# Access Compliance Report

## Public Rights-of-Way

Intersection ID: 47300	Main Street: LELA_AV	Cross Street: HURSTON_CR	Location: S
ADA ID: 41ACF8A03CC3	Ramp Type: BlendTrans1	Initial Pass/Fail: Fail	Overall Compliance: No
			Severity Score: 21.25

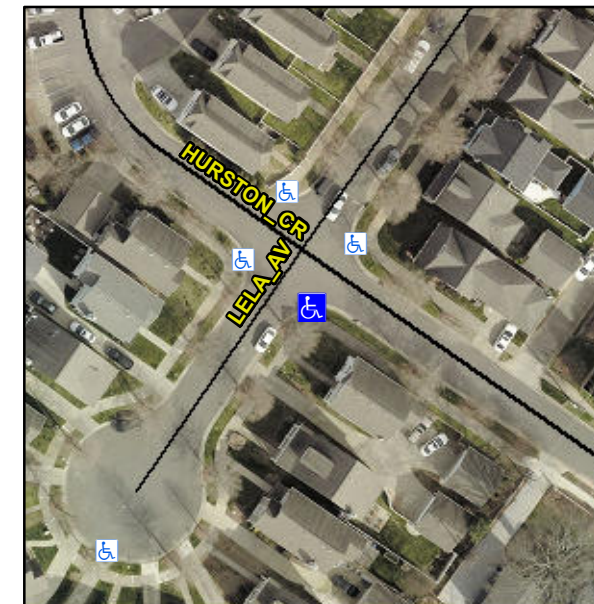
**R304.5.1, R304.5.3**

Compliance	Description	Data	Compliance	Description	Data
N/A	Ramp Length (in)	68.5	Yes	BlendTrans Slope (%)	2.3
No	Ramp Width (in)	39.0	No	BlendTrans XSlope (%)	5.5
N/A	Flare Type LT	N/A	N/A	Flare Type RT	N/A
N/A	Flare Slope LT (%)	N/A	N/A	Flare Slope RT (%)	N/A
N/A	Flare Traversable LT?	N/A	N/A	Flare Traversable RT?	N/A
N/A	Landing Length (in)	N/A	N/A	DWS Provided?	N/A
N/A	Landing Width (in)	N/A	N/A	DWS Contrast?	N/A
N/A	Landing Slope (%)	N/A	N/A	DWS Length (in)	N/A
N/A	Landing X Slope (%)	N/A	N/A	DWS Full Width?	N/A
N/A	Landing Curb? (Y/N)	N/A	N/A	DWS Offset (in)	N/A
N/A	Shared Landing?	N/A			
N/A	Gutter Ponding?	N/A	N/A	Gutter Slope (%)	N/A
N/A	Gutter Lip Ht (in)	N/A	N/A	Gutter X Slope (%)	N/A
N/A	Painted X Walk1?	No	N/A	Painted X Walk2?	No
	X Walk 1 Direction	To NE		X Walk 2 Direction	To NW
	X Walk 1 Width (in)	N/A		X Walk 2 Width (in)	N/A
	X Walk 1 Slope (%)	0.6		X Walk 2 Slope (%)	4.6
	X Walk 1 X Slope (%)	3.5		X Walk 2 X Slope (%)	1.6

**Remove & Replace Curb Ramp With Two New Directional Ramps or Equivalent.**
